Agenda
City of Springboro Planning Commission Meeting
Wednesday, March 13, 2024, 6:00 p.m.
Council Chambers, City Building, 320 West Central Avenue

Record Plan, Village Park PUD-MU, Planned Unit Development-Mixed Use, office component, replat of Clearcreek Township Fire Station #24 site

Site Plan Review, southwest terminus of West Tech Boulevard, new building for Caesar Creek Software

Final Development Plan, 1525 South Main Street (SR 741), Northampton PUD-R, Planned Unit Development-Residential, residential subdivision

VILLAGE PARK OFFICES, PHASE 1A

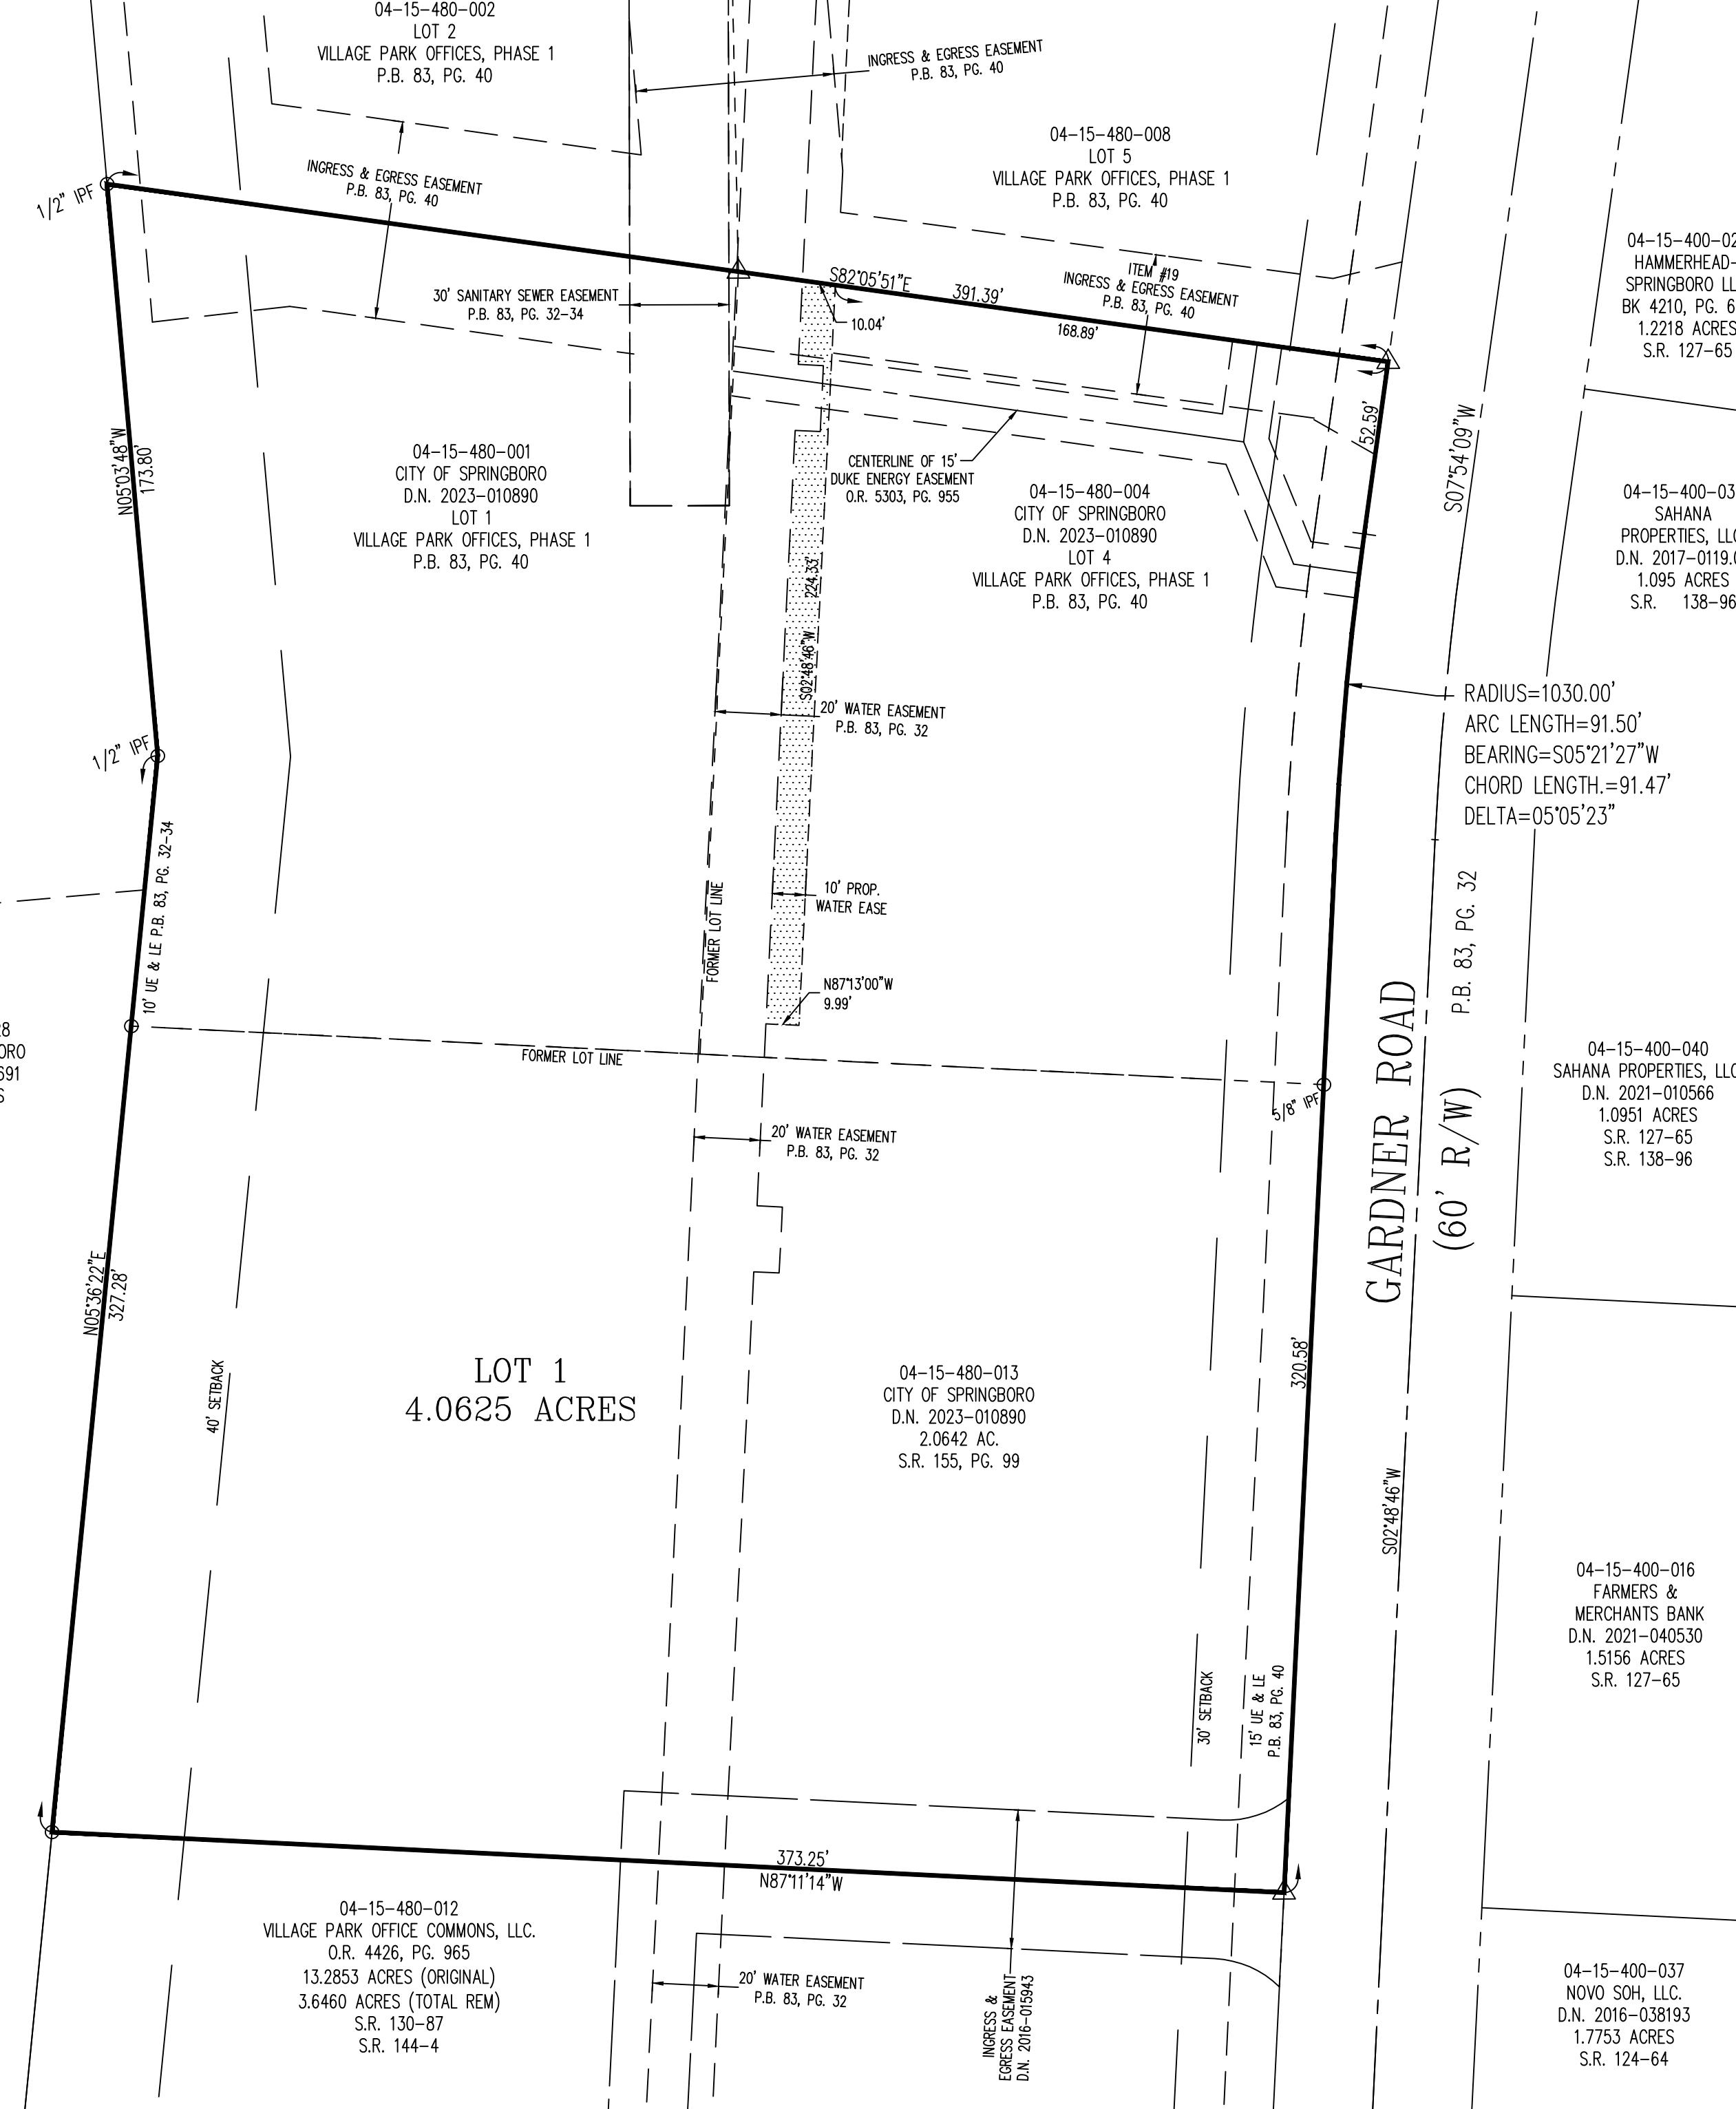
1. Submit record plan to Warren County for review and make revisions, if any.
2. Remove notes #6, 7 and 9.

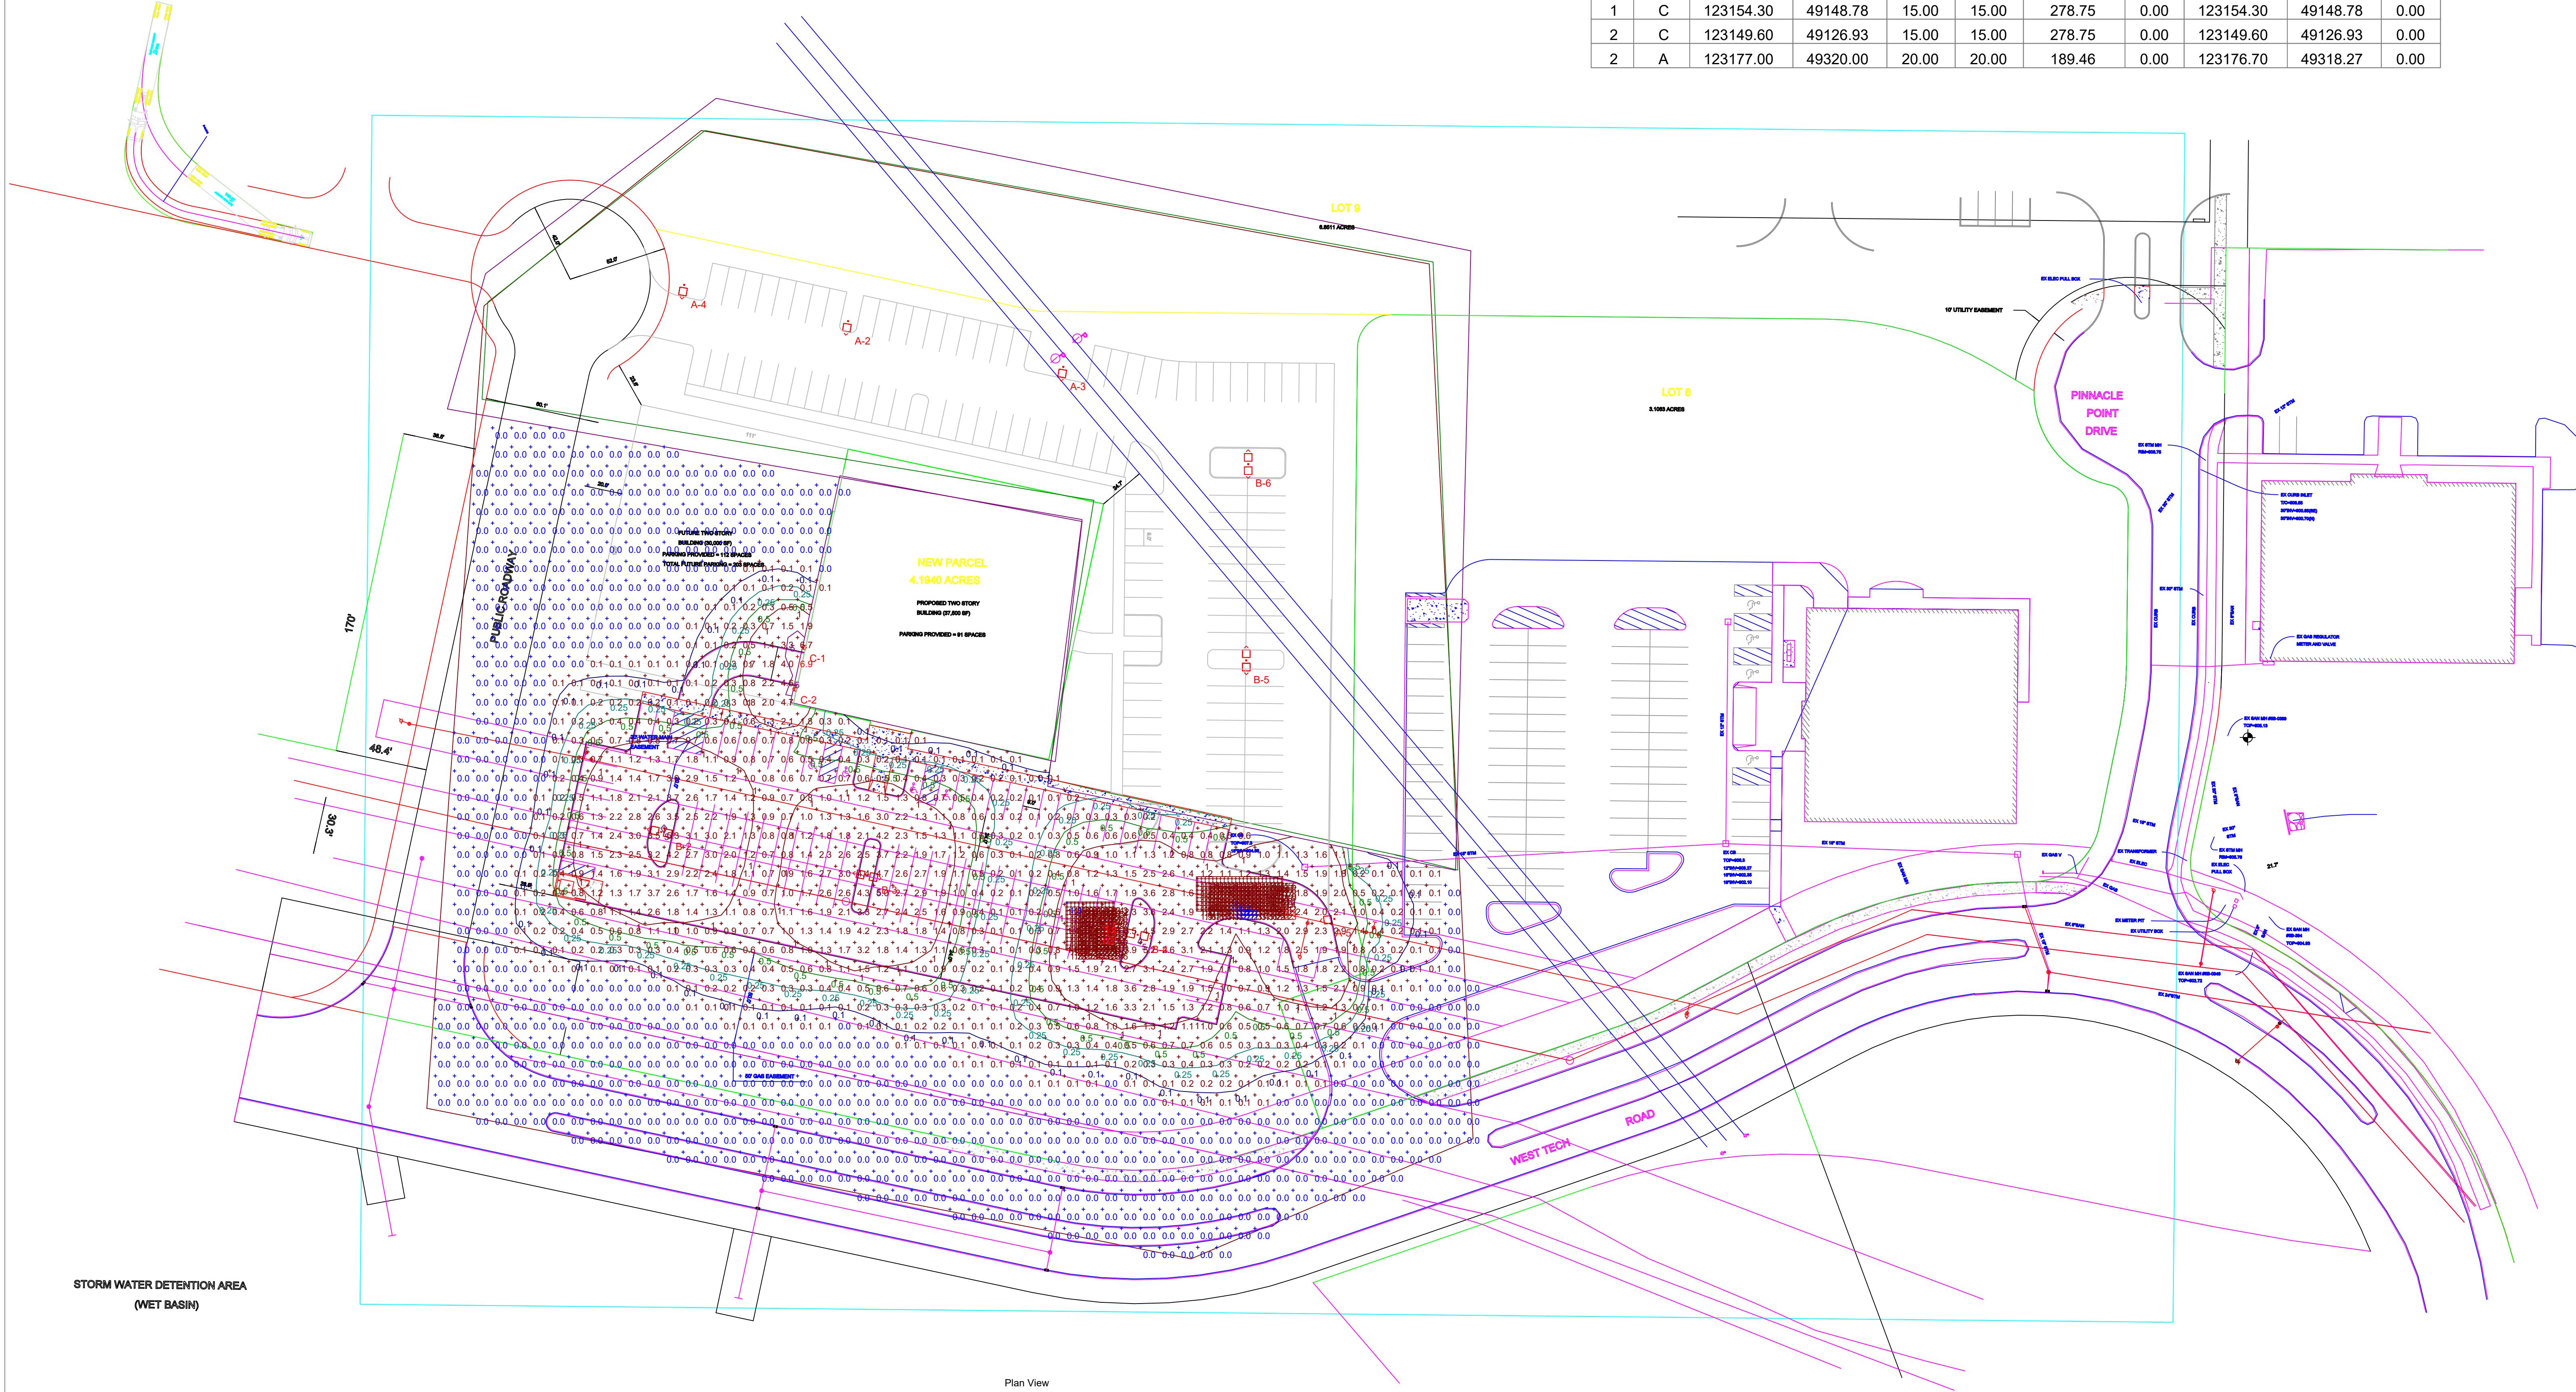
2. Indicate lot coverage for site at build-out; maximum lot coverage for the ADD-1 is 85%.
3. For the proposed lighting plan, address the following:
 - a. Proposed parking lot illumination falls below the acceptable minimum of 0.4 foot-candles.

- b. Provide spec sheet for proposed RAB lighting fixture; also if applicable confirm that any architectural lighting proposed for the building complies with code provisions

- c. Confirm that proposed color-temperature of exterior lighting is 3500 Kelvin or less.
4. Landscaping plan to be revised to provide additional trees on the West Tech Boulevard frontage, and foundation plantings adjacent to the building.
